RFQ #7464395

Title: Rhode Island State Police HQ Parking Improvements

ADDENDUM # 2

DRAWING TITLE: SITE LAYOUT PLAN

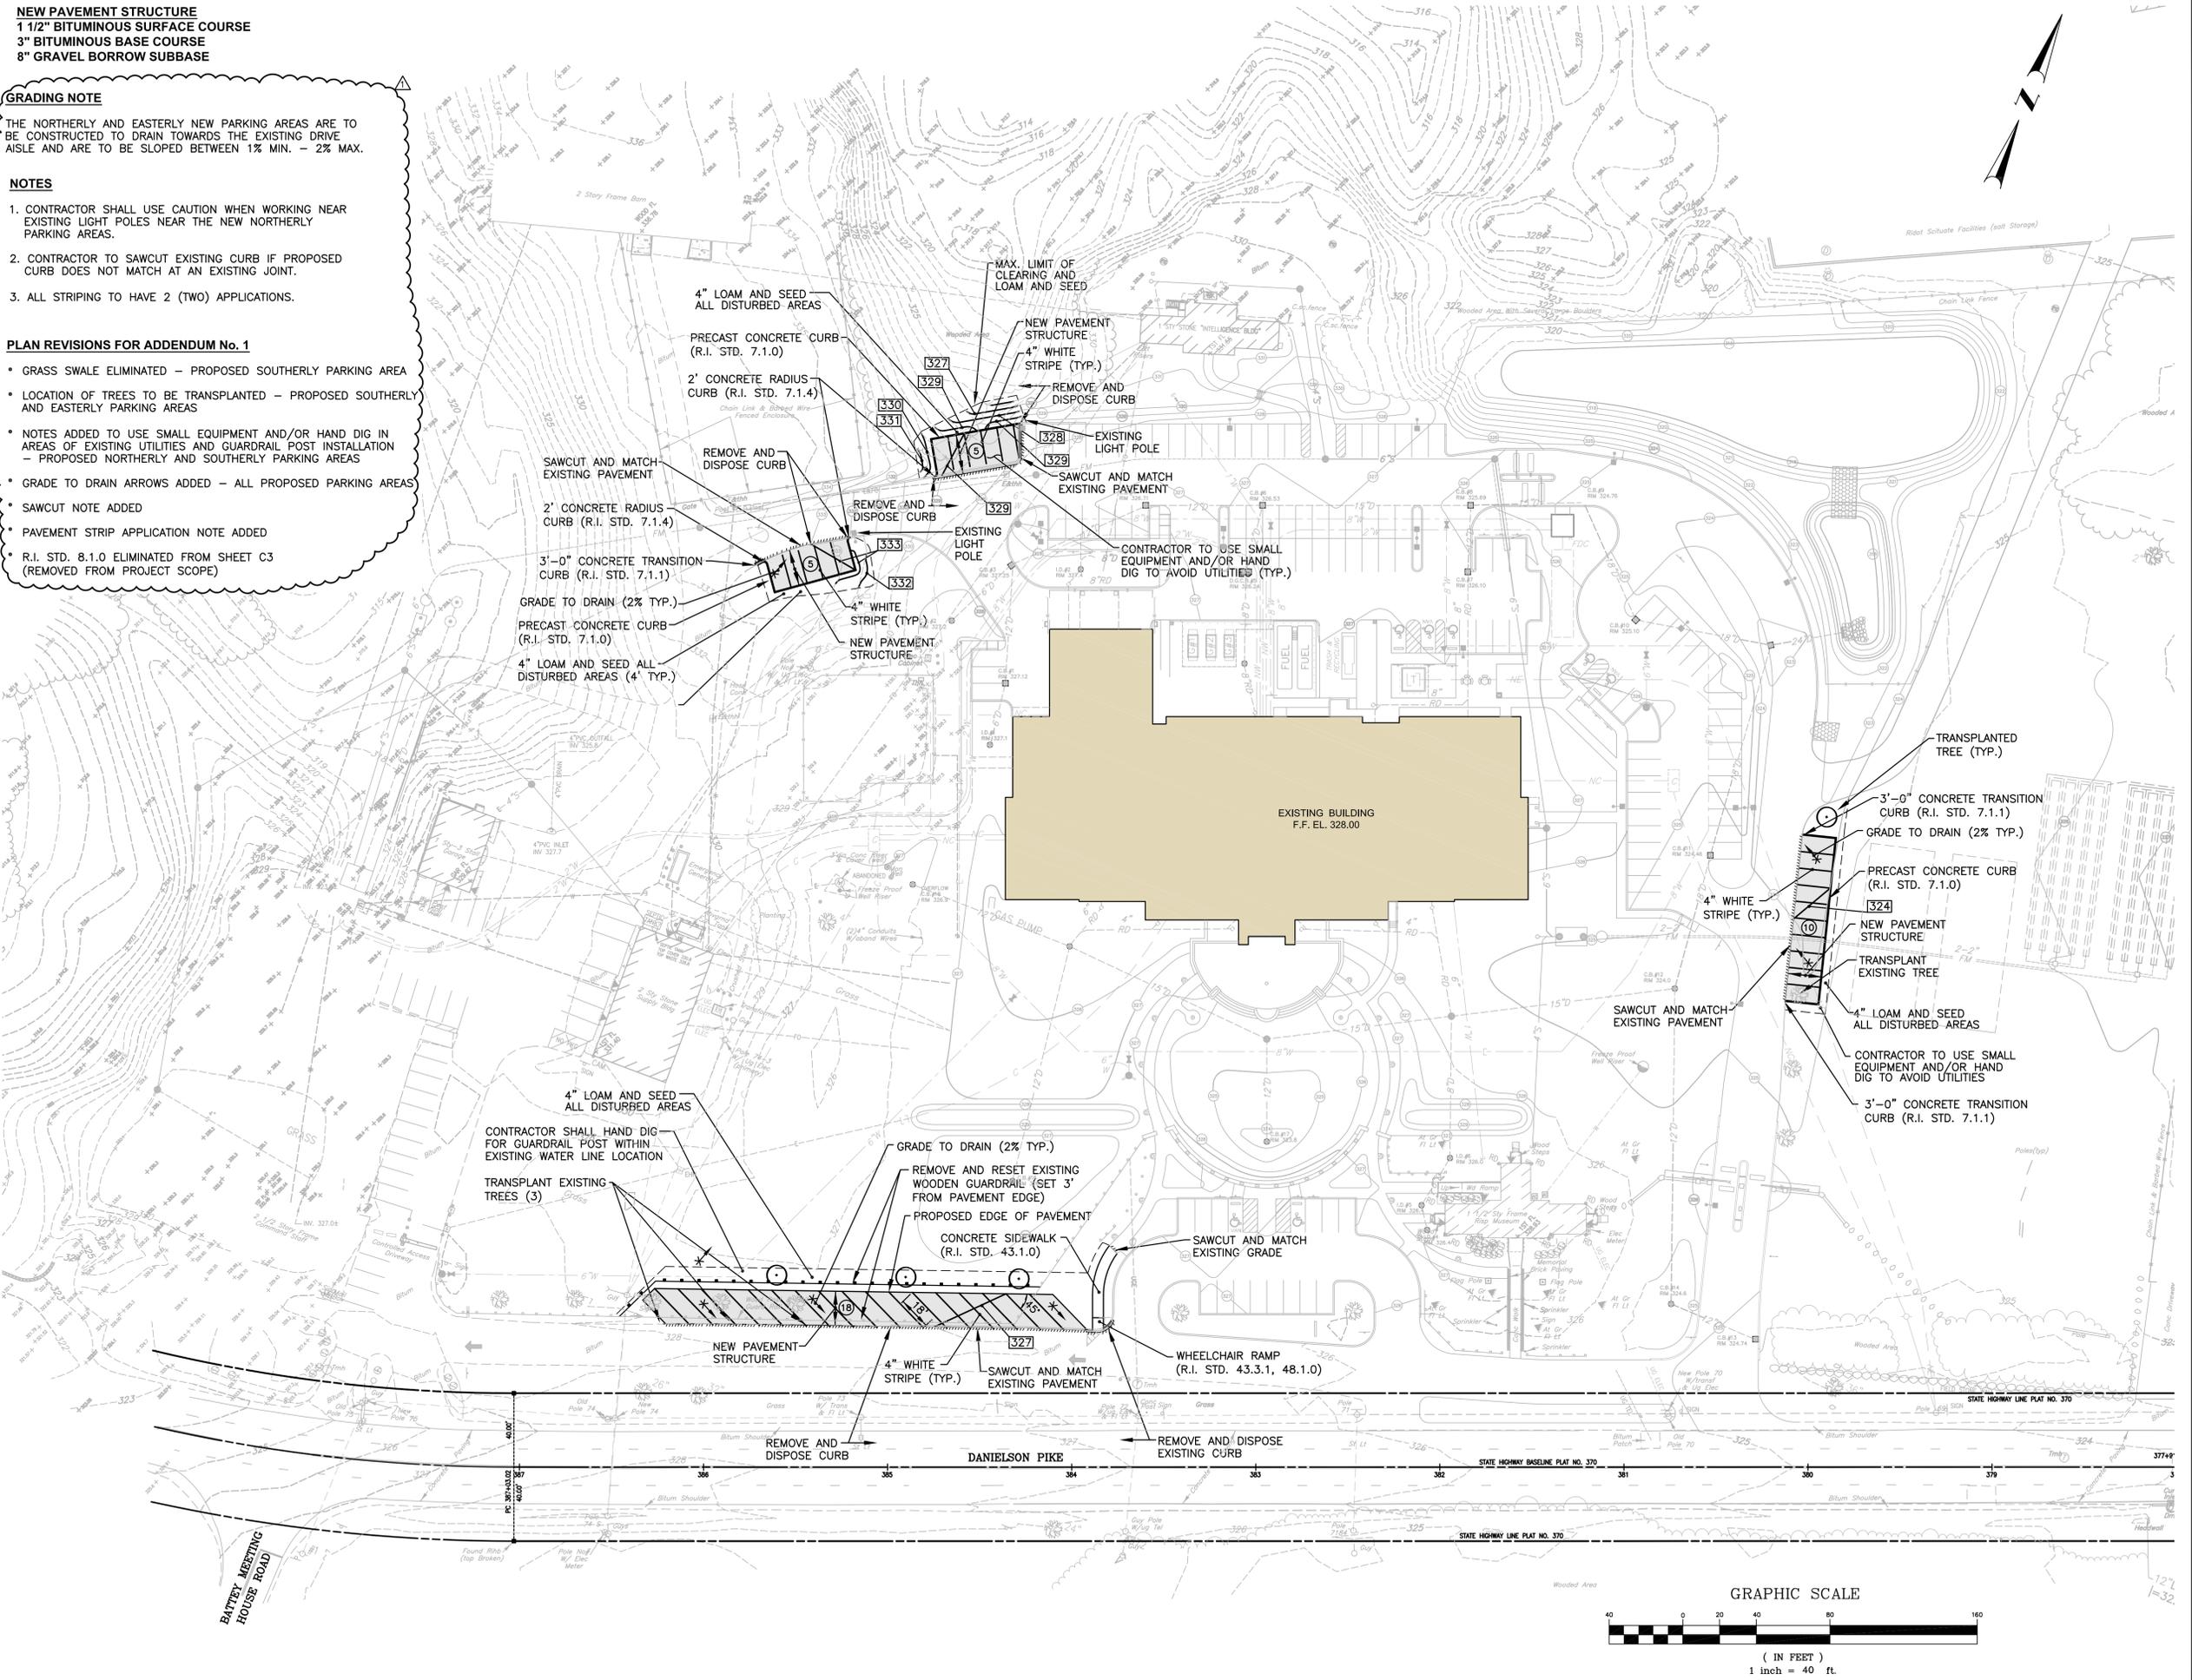
Question 10. Drawing number C-2 indicates trees to be transplanted. Where are the locations for the transplanted trees?

PLAN REVISIONS FOR ADDENDUM No. 1

- GRASS SWALE ELIMINATED - PROPOSED SOUTHERLY PARKING AREA
- LOCATION OF TREES TO BE TRANSPLANTED - PROPOSED SOUTHERLY AND EASTERLY PARKING AREAS
- NOTES ADDED TO USE SMALL EQUIPMENT AND/OR HAND DIG IN AREAS OF EXISTING UTILITIES AND GUARDRAIL POST INSTALLATION - PROPOSED NORTHERLY AND SOUTHERLY PARKING AREAS
- GRADE TO DRAIN ARROWS ADDED - ALL PROPOSED PARKING AREAS
- SAWCUT NOTE ADDED
- PAVEMENT STRIP APPLICATION NOTE ADDED
- R.I. STD. 8.1.0 ELIMINATED FROM SHEET C3 (REMOVED FROM PROJECT SCOPE)

A. See attached Revised C-2 Drawing.
